WASHINGTON HIGH SCHOOL

Re: Storm Water Inspection at Washington High School/Permit #4GC03036*AG

Figure 1: Willard Street

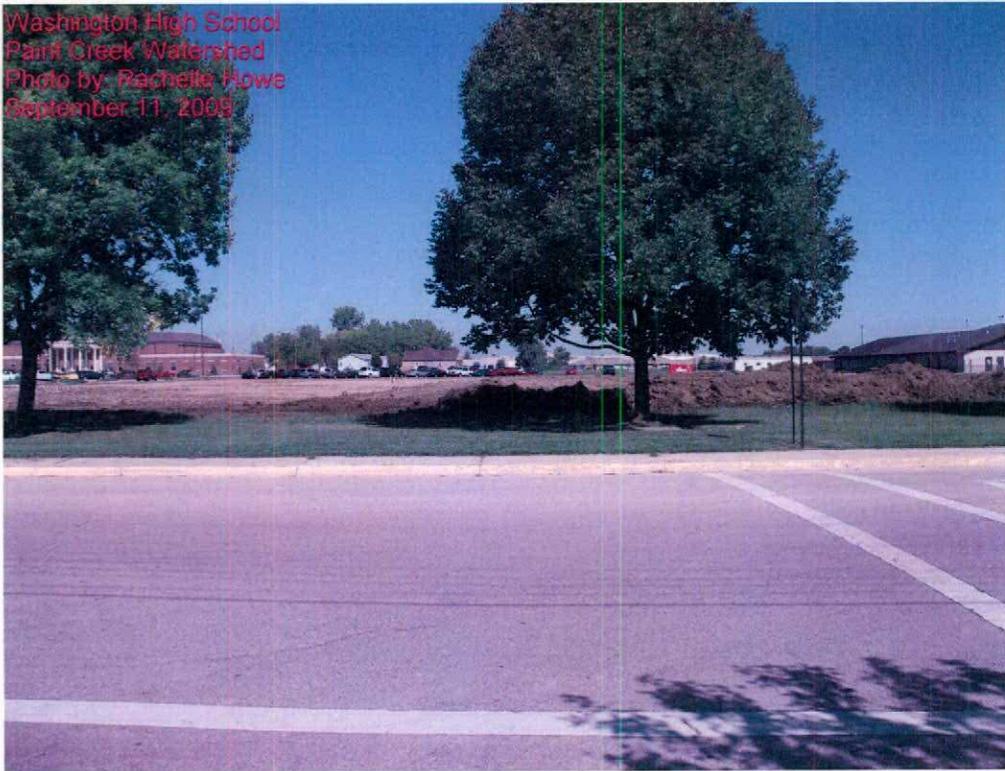
- The site appears to be void of sediment controls. In order to meet the requirements of the General Storm Water Permit, silt fence should be installed along Willard Street to prevent sediment from leaving the site (see Photo Figure 1).
